Service Letter No. 425

SUBJECT: Lycoming Service Bulletin No. 298
(Fuel and Oil Vent Restriction Requirement for AC Lightweight Diaphragm Fuel Pumps)

MODELS AFFECTED: PA-23-235 Apache and PA-23-250 Aztec aircraft, Serials 27-1 to 27-593 inclusive

Figure 1. AC Fuel Pump with Vent in Upper Chamber

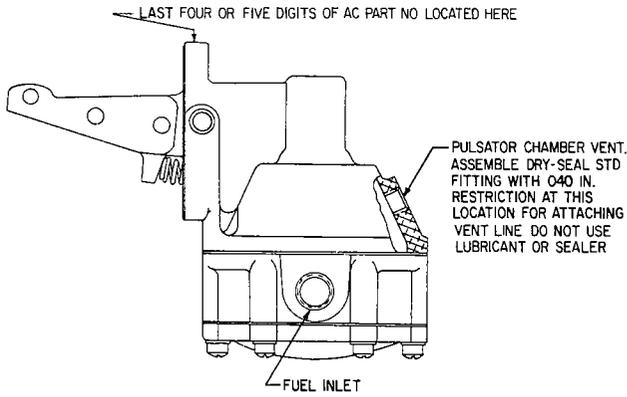
All the fuel pumps affected by this bulletin have a single vent opening in the upper chamber as shown in figure 1, except the P/N 73870 (AC 5658696) which has

1. Determine applicability of this procedure by observing the AC fuel pump part number stamped on the upper edge of the mounting flange as shown in figure 1. Only the last four or five digits of the AC part number are stamped on the pump.

a vent opening in both the upper chamber and the separator ring as shown in figure 2. Regardless of which of the two types are found on the engine, the restriction described herein is to be installed only in the vent opening or line from the upper chamber; do not change the line connected at vent in separator ring.

Figure 5. Restriction for Installation in Hose

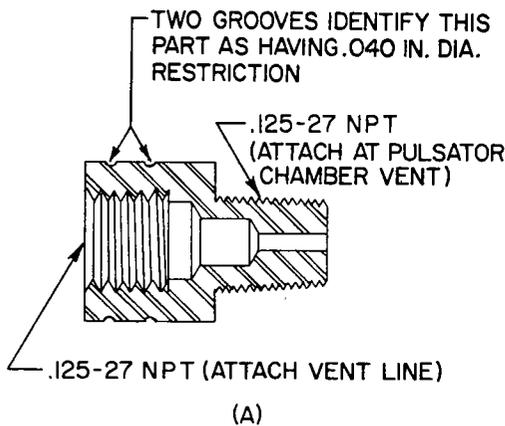
c. Fuel drain lines that employ a hose can be modified by installing the restriction in the hose and securing by a clamp. A restriction can be fabricated, as shown in figure 5, installed in the hose and secured.

Figure 3 (A). Lycoming P/N 75250 Overboard Drain Adapter

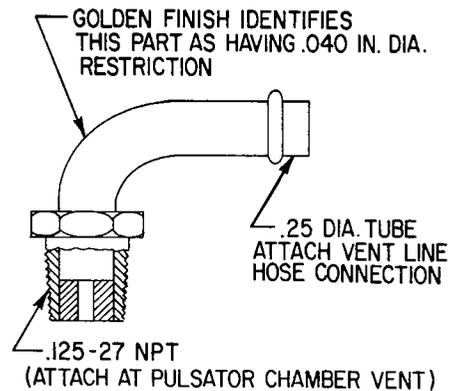
2. There are two restriction adapters available from Lycoming for installation in the tapped vent hole of the fuel pump. Lyc. P/N 75250 adapter which is generally suitable for most aircraft fuel system installations, and Lyc. P/N 75307 elbow adapter which is designed for installations where a hose coupling is required in the vent line, such as the Piper Comanche, Model PA 24-250. Both adapters, and their method of installation, are shown in figure 3.

Both adapters, P/N 75250 and 75307, incorporate a 0.040 inch diameter restriction and are identified as follows: The P/N 75250 adapter has two circular grooves around its hex portion. The P/N 75307 adapter can be identified by its golden color as contrasted with the white, cadmium plated elbow fitting that is usually installed at similar locations.

Figure 4. Typical Connector Fitting with .040 Restriction Installed

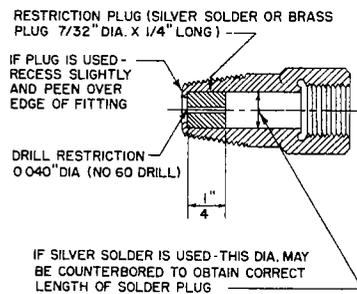
3. In some installations the connector between the fuel pump and vent line may be a standard flared fitting with a 7/32 inch diameter hole in the male end, similar to the one shown in figure 4. There are two methods (a or b) which a restriction may be installed in this fitting, or an alternate third method (c) for putting a restriction in the hose.

a. Fill the hole in the fitting with silver solder (if the fitting is steel) and drill a 0.040 inch diameter hole through the silver solder to form the restriction. If necessary, counterbore the solder filled

area to maintain the length of the restriction to 1/4 inch. Thoroughly clean the fitting and re-install it in the fuel pump.

b. Press a 7/32 inch diameter x 1/4 inch long plug in the hole of the fitting. Peen the end of the fitting to secure the plug and drill a 0.040 inch diameter hole (No. 60 drill) through the plug to form the restriction. 7/32 inch diameter bronze welding rod may be used to make the plug. Thoroughly clean the fitting and re-install it in the fuel pump.
